ADDENDUM NO. 1  
TO  
CITY OF AUBURN, MAINE  
2023 RECONSTRUCTION PROJECT  
March 22, 2023

This addendum amends and /or supplements the bid documents as indicated below. Only these items alter the bid documents. Any verbal discussions or responses are hereby declared null and void. Please acknowledge this addendum on the Bid Form.

## LIGHT POLE BASE

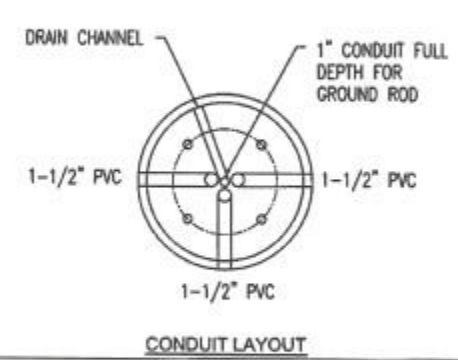
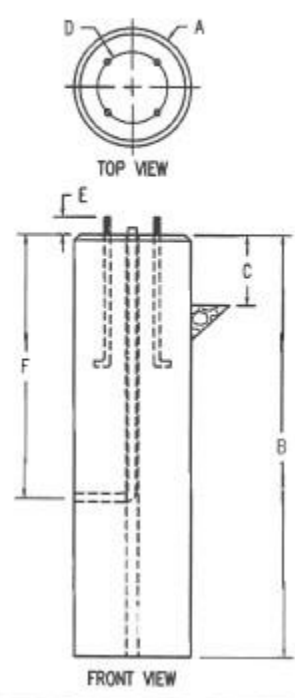
Question: Please advise regarding the overall length of the foundation that is shown.

Answer: Total height of the bases are 5'6". Total diameter is 20". Omit light base diagram on page 33 of 57 of the RFP and replace with diagram below (Addendum 1 page 2 of 2).

DIAMETER (A):	20"
HEIGHT (B):	5'-6"
ABOVE GRADE (C):	TBD
WEIGHT/CY	(1,776 LBS) (0.44 CY)

- CONCRETE TO BE MEDOT, CLASS LP. AIR 6.5% ± 1% 5,000 PSI AT 28 DAYS (USE MIX: 10A-LP).
- REBAR TO BE ASTM A615 GRADE 60, BLACK.
- REINFORCING: 7 - #6 VERTICALLY WWF 3XB W3.75/W2.1 HORIZONTALLY.
- MIN REBAR CLEARANCE, 3" @ ENDS, 2" @ FACE OF CONCRETE.
